**CALIFORNIA COASTAL COMMISSION**

**Prepared July 10, 2014 for July 11, 2014 Hearing**

**Subject: STAFF REPORT ADDENDUM for F15a**  
**Application Number 3-13-012 (Caltrans Highway One Realignment Project)**

Highway with 4-foot wide paved shoulders

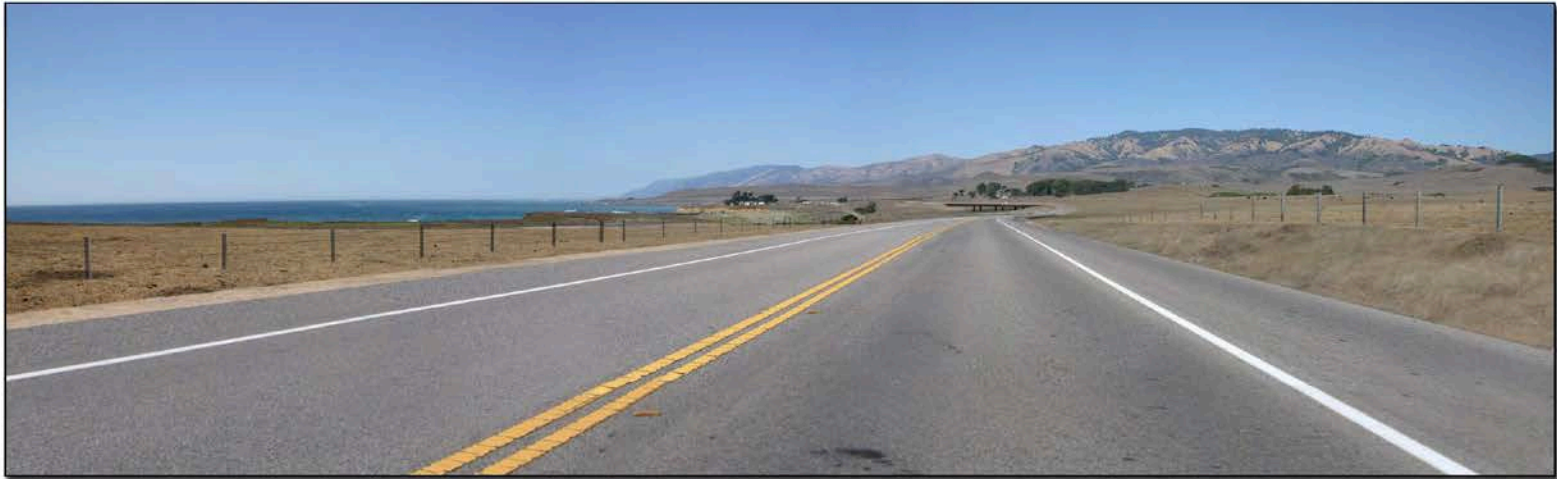
Finally, a note of clarification. The visual simulations provided by the Applicant (and shown in Exhibit 8) do not correctly show the expected future condition as conditioned. Specifically, the Applicant submitted visual simulations showing an eight-foot paved shoulder and a four-foot paved shoulder, which Commission staff requested at that time. In the time since then, the recommendation has shifted to a 5-foot paved portion of the shoulder, including to better address issues raised by the Applicant and others regarding safety. Thus, the smaller shoulder width in Exhibit 8 needs to be understood in that context, including that the as conditioned project would have one more foot of paving than shown in Exhibit 8.
